517-P50E-080P1-RR1EA

Project LIGO DAC 32		LIGO Laboratory California Institute of Technology Massachusetts Institute of Technology National Science Foundation	
Sheet Title DAC Proto Top Sheet			
Size: B	DCC D2200368	Rev: 1	
Date: 2/8/2024	Time: 1:46:36 PM	Sheet: 1 of 17	DrawnBy: M. Pirello, D. Sigg
File: LD32_TOP.SchDoc

Project LIGO DAC 32			LIGO Laboratory California Institute of Technology Massachusetts Institute of Technology National Science Foundation
Sheet Title VCO & Phase Detector			
Size: B	DCC D2200368	Rev: 1	
Date: 2/8/2024	Time: 1:46:37 PM	Sheet: 2 of 17	
File: LD32_PHASE.SchDoc

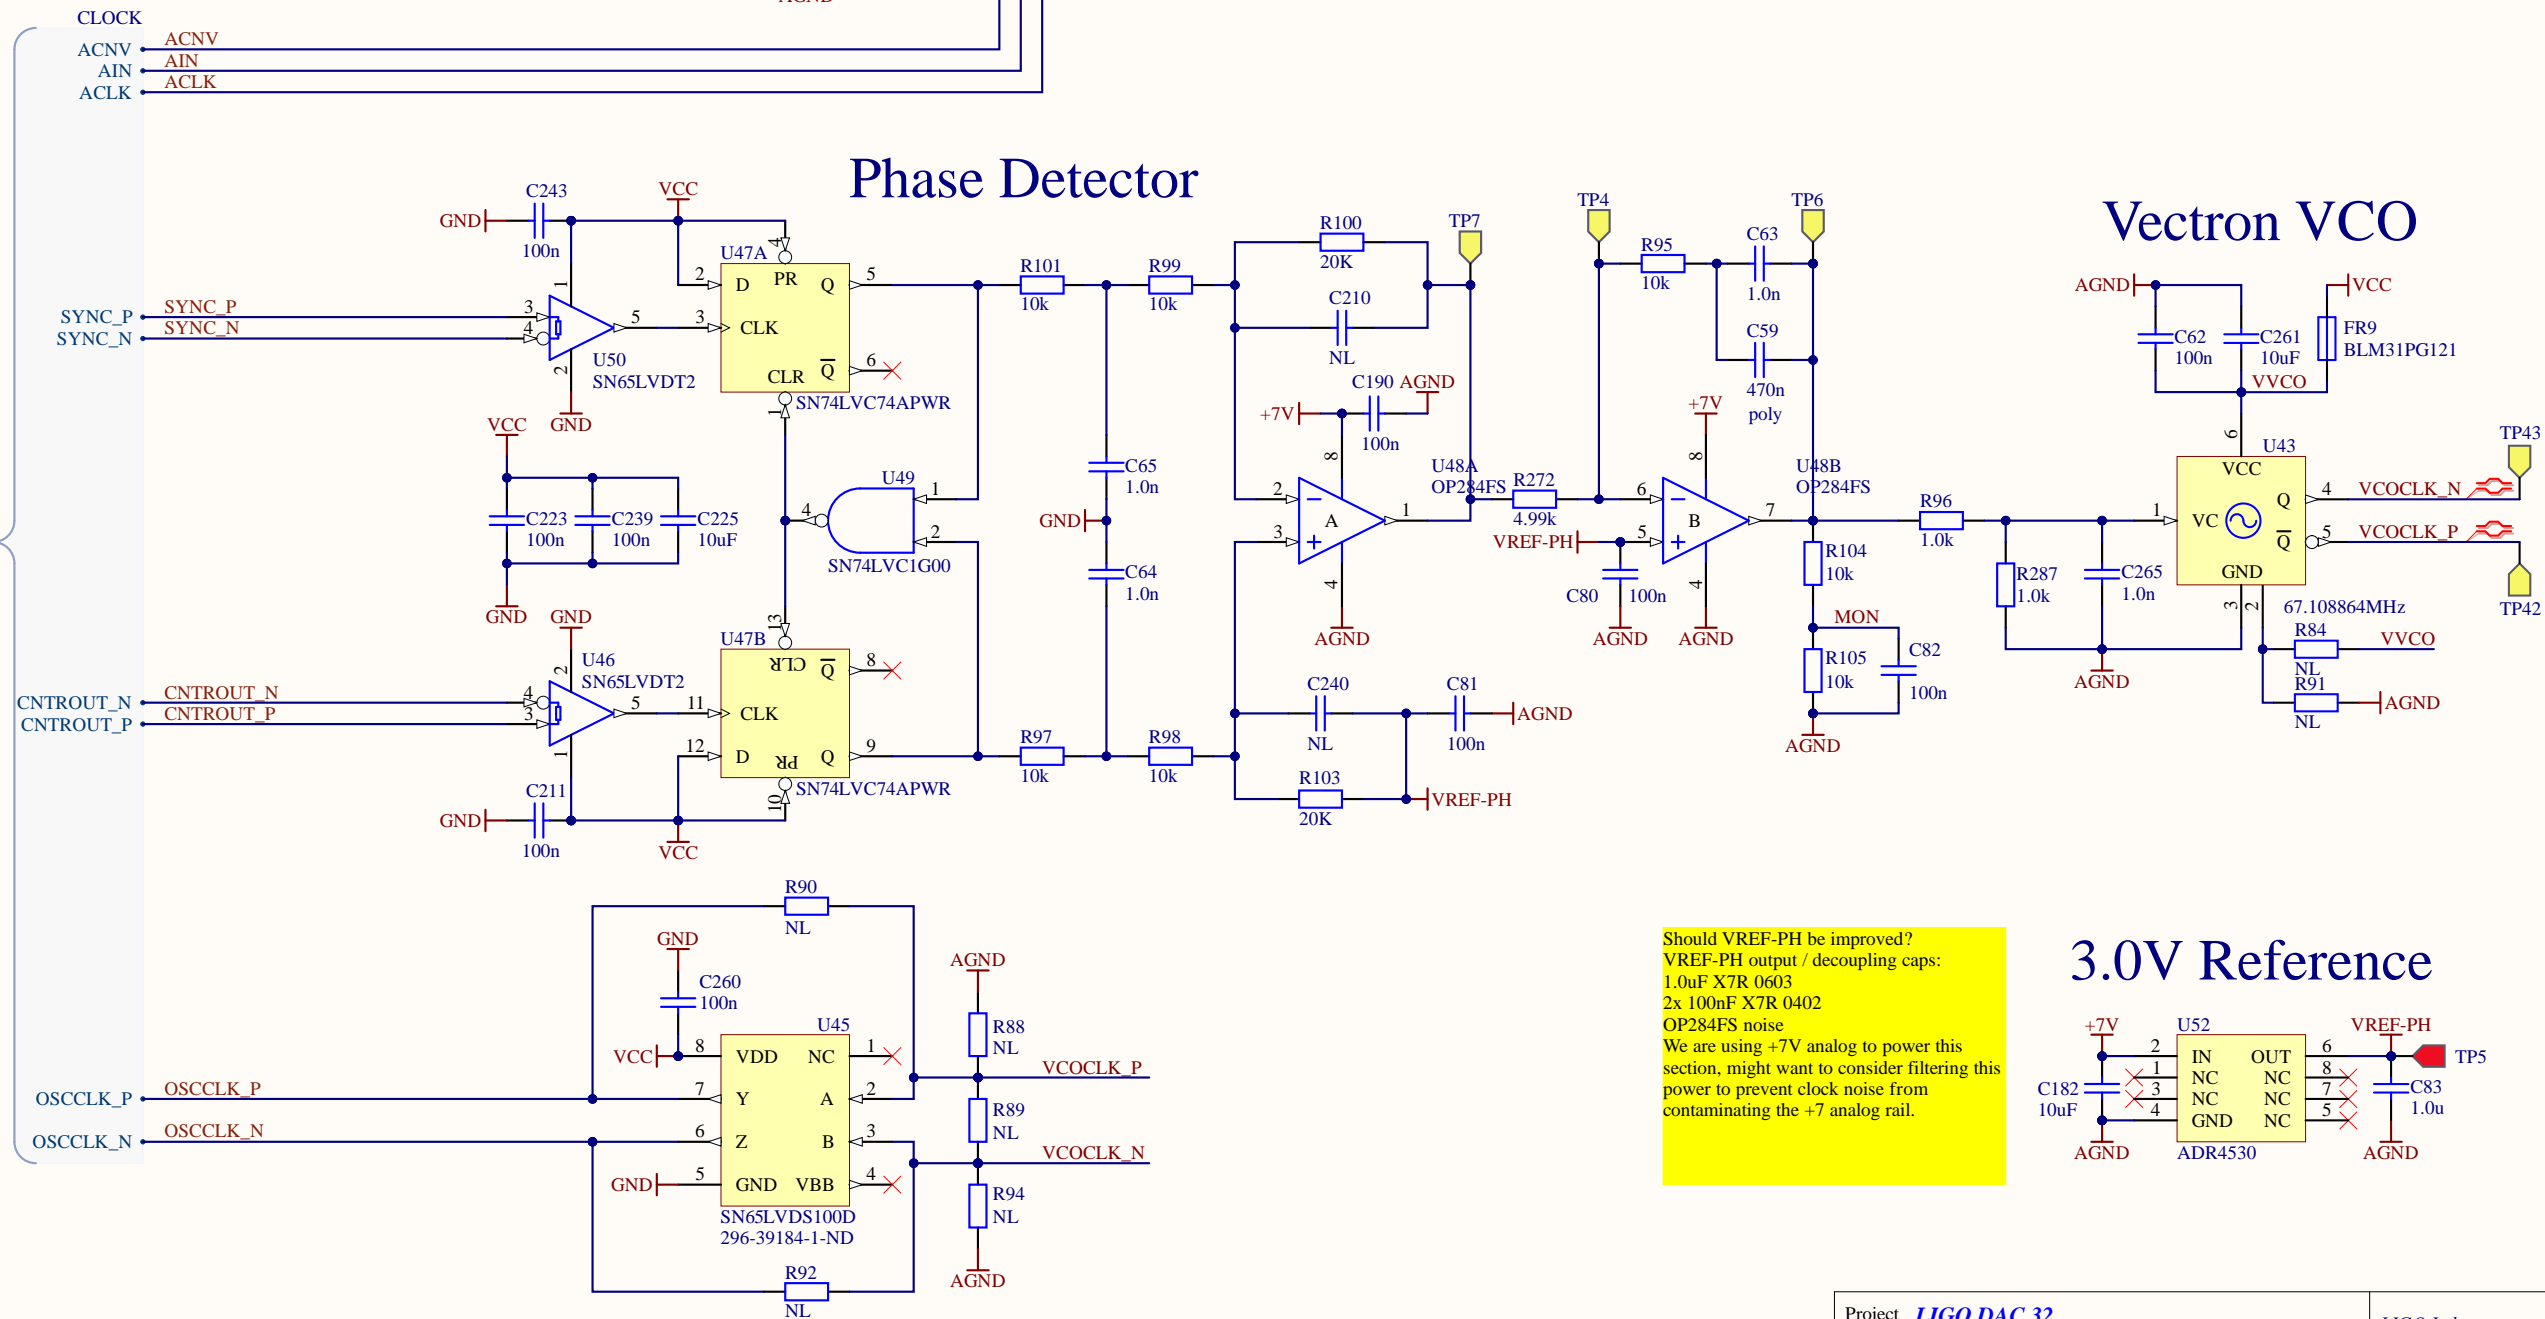
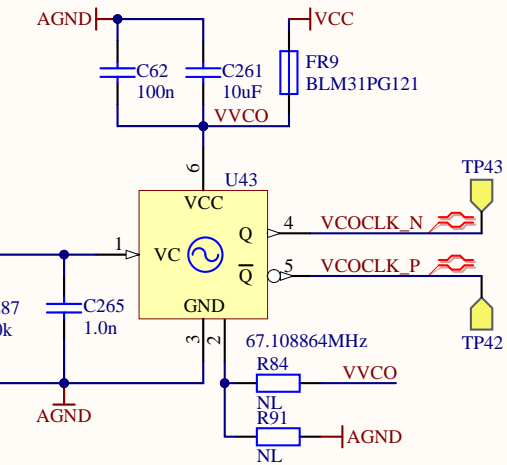
Should VREF-PH be improved?
 VREF-PH output / decoupling caps:
 1.0uF X7R 0603
 2x 100nF X7R 0402
 OP284FS noise
 We are using +7V analog to power this section, might want to consider filtering this power to prevent clock noise from contaminating the +7 analog rail.

Project LIGO DAC 32		LIGO Laboratory California Institute of Technology Massachusetts Institute of Technology National Science Foundation	
Sheet Title DAC			
Size: B	DCC D2200368	Rev: 1	
Date: 2/8/2024	Time: 1:46:38 PM	Sheet: 14 of 17	DrawnBy: M. Pirello, D. Sigg
File: LD32_DAC.SchDoc

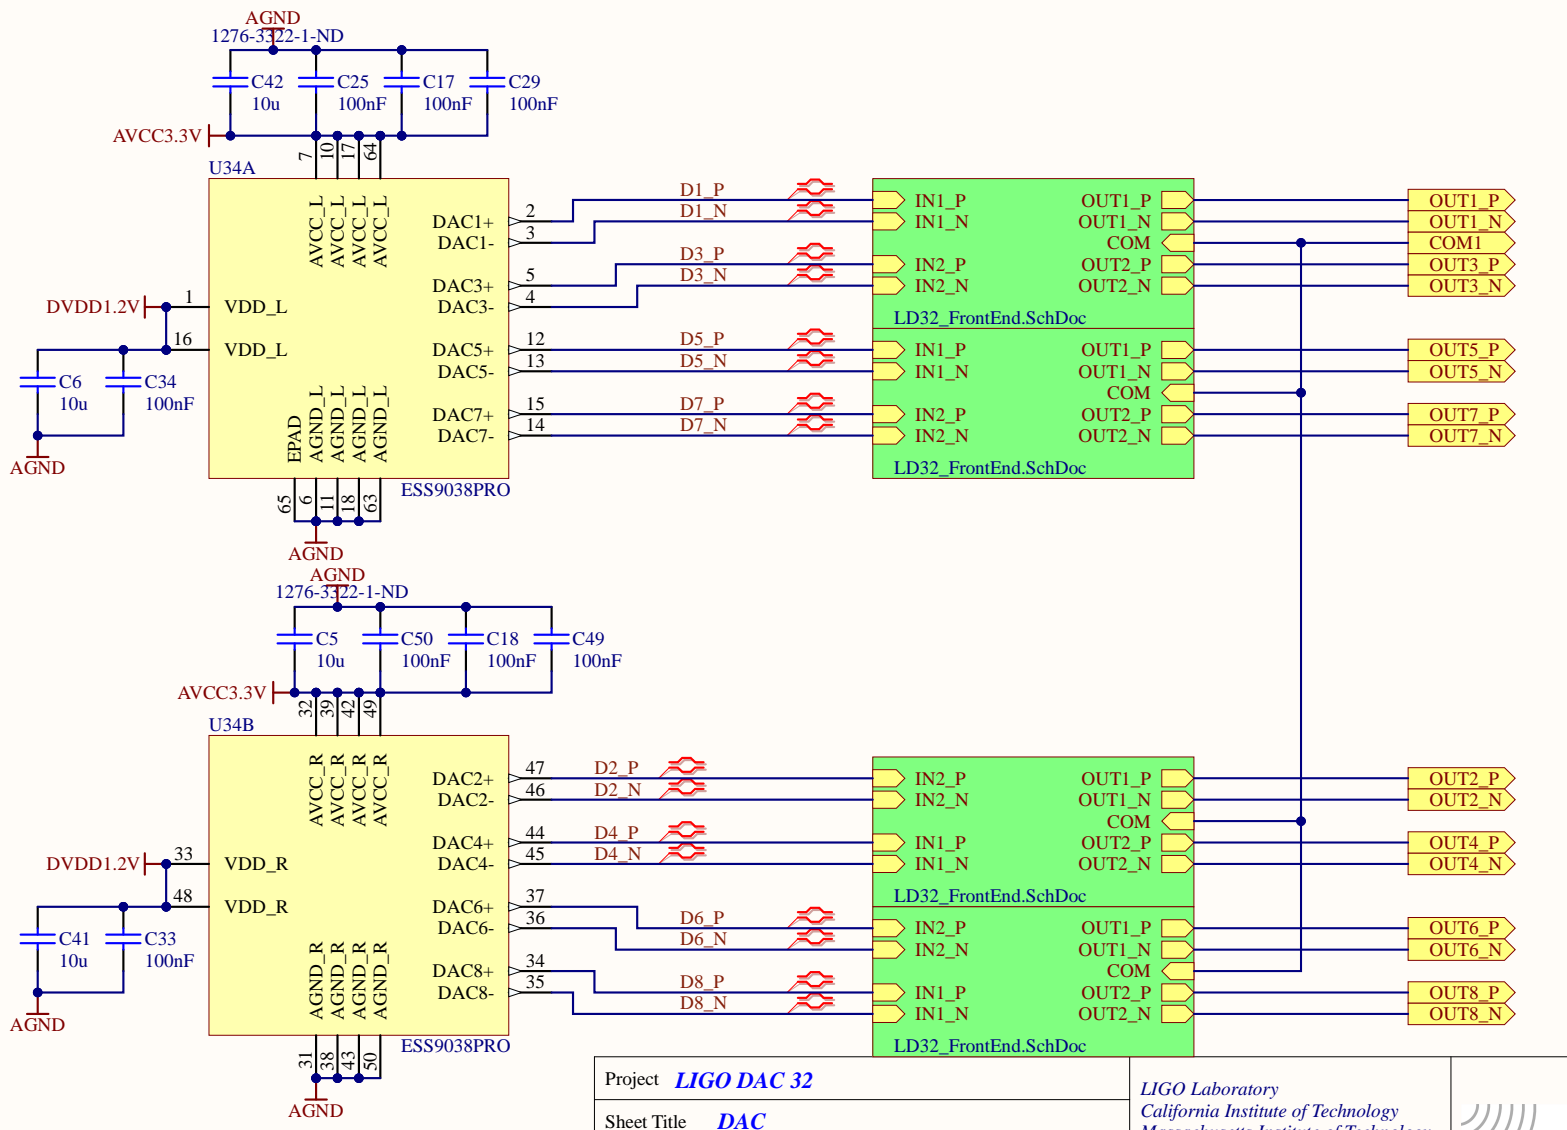
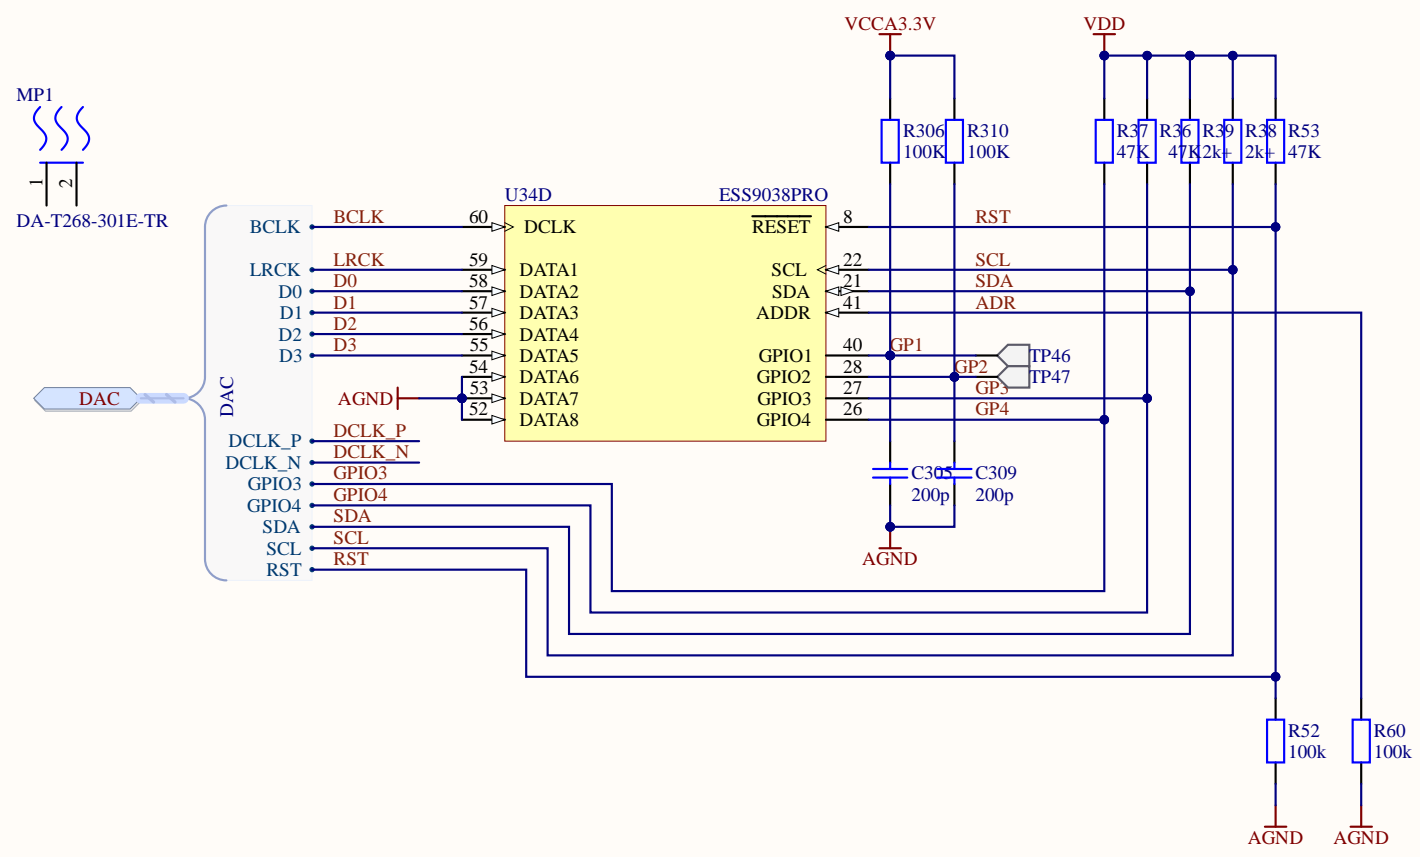
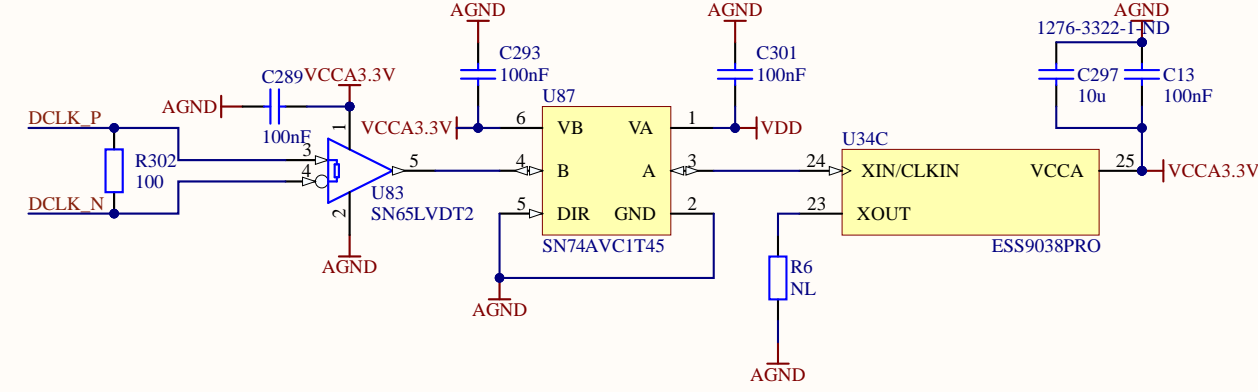
Clock lines and reset could be shared in principle.
 You also routed more lines than we really need.

1 fast clock (LVDS, SN65LVDS104 for FO)
 1 BCLK
 1 LRCLK
 4 D lines
 2 I2C lines
 is needed per DAC.

There will be a difference between Artix-7 and Artix Ultrascale with later only supporting 1.8V.
